# PRODUCT CHANGE NOTIFICATION

## Change to Manufacturing Process Automation and Winding Method

### *Model SDR1006 and PM105 Series*

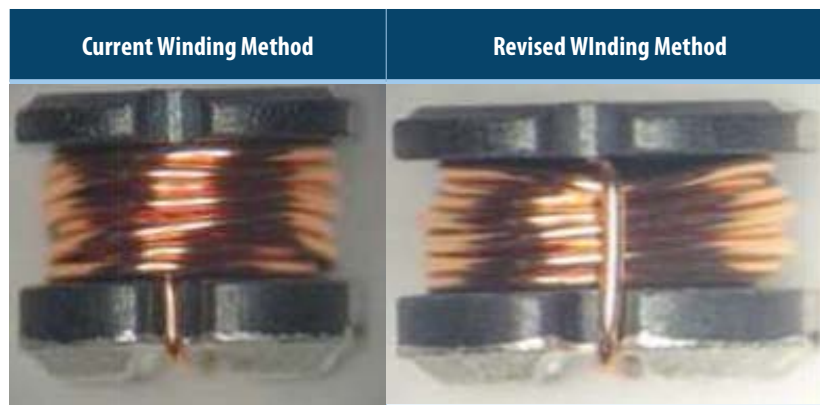
Riverside, California – August 18, 2020 - **REVISED August 25, 2020** – Effective February 6, 2021, Bourns is changing the winding and soldering process for the Model [SDR1006](#) and [PM105](#) Non-Shielded Power Inductor Series from manual / semi-automated to automated as part of the manufacturing process enhancement.

In addition, the inductor's winding starting turn will begin at the top of inductor core instead of from the bottom. The revised winding method helps ensure that the wire insulation of the start turn will be less impacted by soldering heat from the tinning process.

The form of the products will be changed. The fit and function will remain the same. The quality and reliability of the inductor will be improved. A list of affected part numbers is included on the following page.
